# CITY OF ALBUQUERQUE

**RE: Veterans Integration Center – Phase 2**  
**2701 Mulberry St. SE**  
**Revised Grading & Drainage Plans**  
**Engineer's Stamp Date: 07/30/2025**  
**Hydrology File: M15D054**  
**Case # HYDR-2025-00270**

VETERANS INTERGRATION CENTER  
GRADING AND DRAINAGE PLAN  
2701 MULBERRY ST S.E.  
ALBUQUERQUE, NM 87106  
PROJECT #2171

REVISION DATE
7/31/2025
07-07-2025
C-1.00

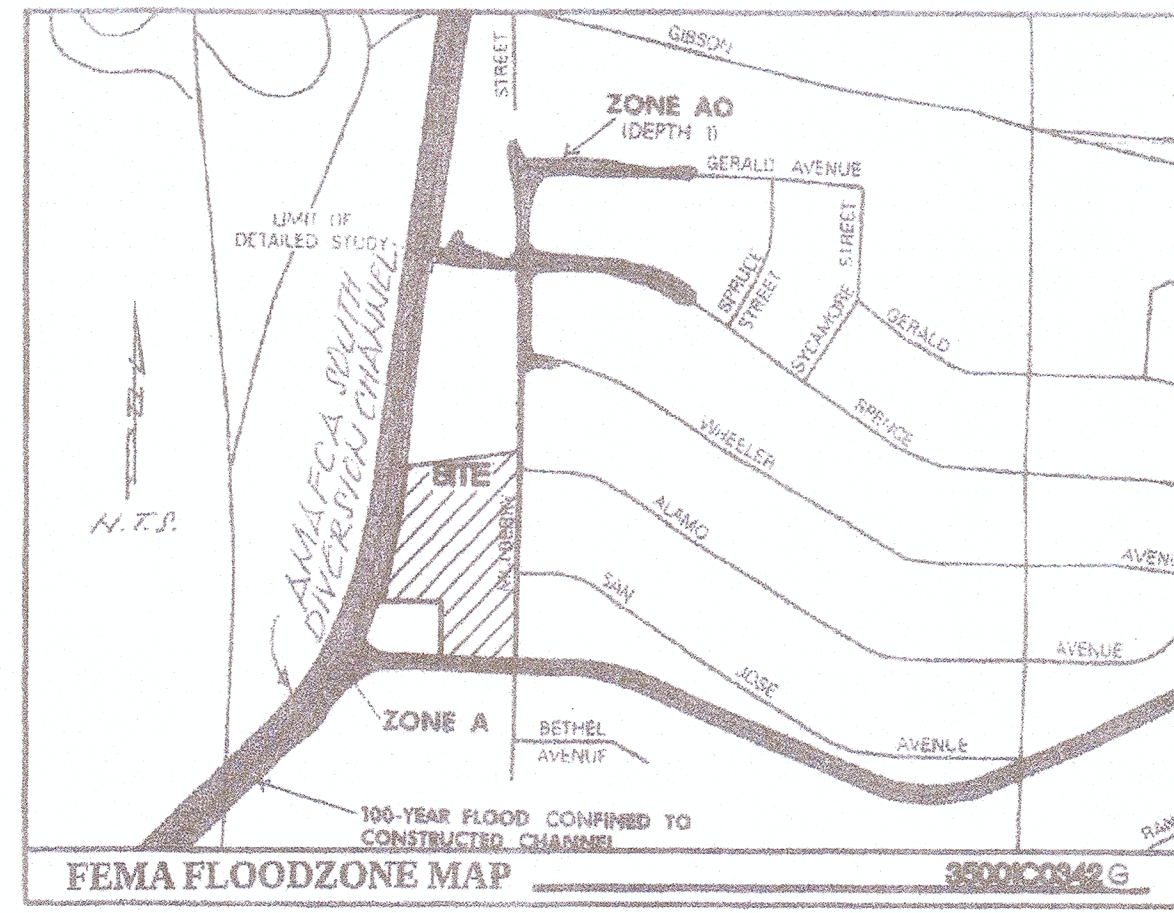
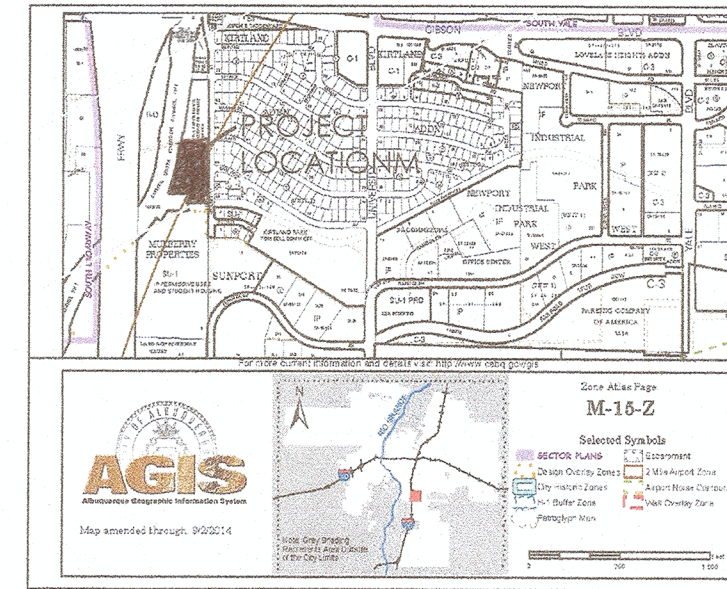
Based upon the information provided in your submittal received 07/31/2025, the Grading & Drainage Plans are approved for Building Permit and Grading Permit. Please attach a copy of this approved plan in the construction sets for Building Permit processing along with a copy of this letter.

1. Engineer's Certification, per the DPM Part 6-14 (F): *Engineer's Certification Checklist For Non-Subdivision* is required.

As a reminder, if the project total area of disturbance (including the staging area and any work within the adjacent Right-of-Way) is 1 acre or more, then an Erosion and Sediment Control (ESC) Plan and Owner's certified Notice of Intent (NOI) is required to be submitted to the Stormwater Quality Engineer (Doug Hughes, PE, [jhughes@cabq.gov](mailto:jhughes@cabq.gov), 505-924-3420) 14 days prior to any earth disturbance.
